**Re: Rapiscan AIT System Radiation Survey Reporting**

## R-0646-1 Addendum (Documentation Errors)

Product Name	Secure 1000SP (Single Pose)
Serial Number	S51002005
Radiation Emission Measurement	Radiation Survey Dated: 06/09/2010
RSO Initials

### 1. In Beam Dose Measurement: Survey Table. 1

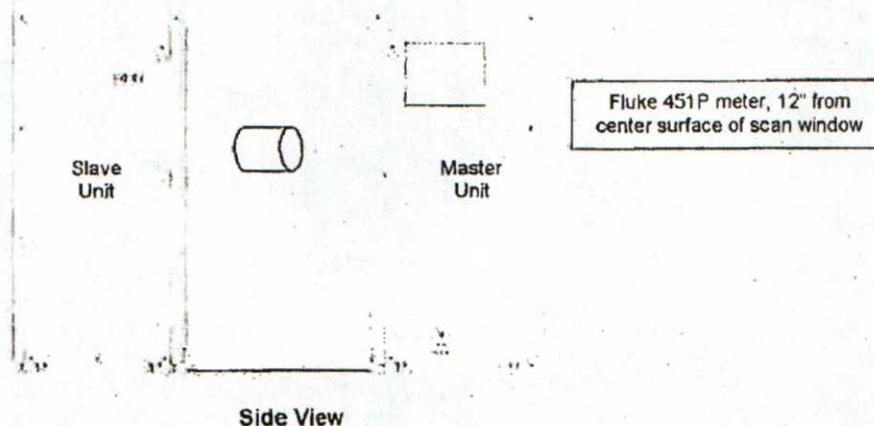
1. Technician indicated scan time as 7 seconds. Correct scan time is 3 seconds.
2. Technician did not record calibration due date for survey instrument. It has been verified by RSO that the instrument was calibrated on April 8, 2010.

RSO will address issue with technician to ensure error is not repeated.

The corrected data indicates this system was operating within expected parameters. No re-survey is required for this system.
